Accessibility Survey

City of Downey Rundell Street - Rives Avenue To Old River School Road

Date of Inspection 4/17/2017

Change In Level West Of Richeon Avenue @ 33.933504259108, -118.154131472111

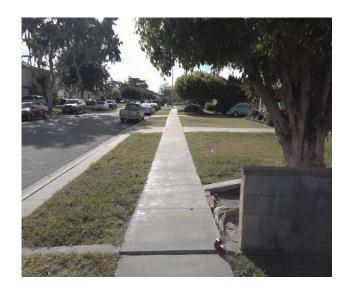
There is a change in elevation greater than recommended value.

On-Site Finding 1.12 inches

Ensure that the change in elevation is within the recommended value.

Recommendation Up to 0.25 inches

Northeast Corner Of Old River School Road @ 33.935123215860, - 118.157540559769

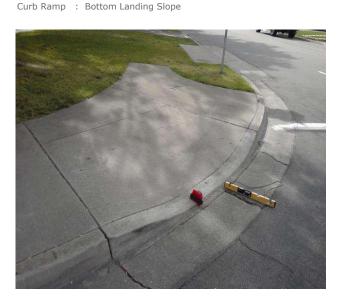
The bottom landing of the curb ramp is on the street, and the slope of the bottom landing is not compliant.

On-Site Finding 6.90 percent

Ensure the bottom landing slope is compliant and provides a smooth transition.

Recommendation Up to 5.00 percent

Sidewalk West Of Richeon Avenue @ 33.933322889528, -118.153766691685

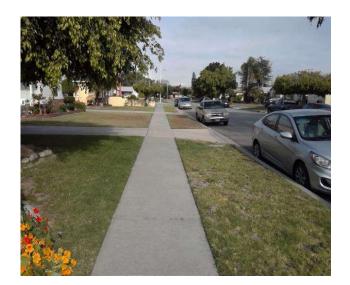
Sidewalk cross slope is not compliant.

On-Site Finding 4.00 percent for 87.00 feet

Repave the sidewalk surface with the recommended cross slope.

Recommendation Up to 2.08 percent
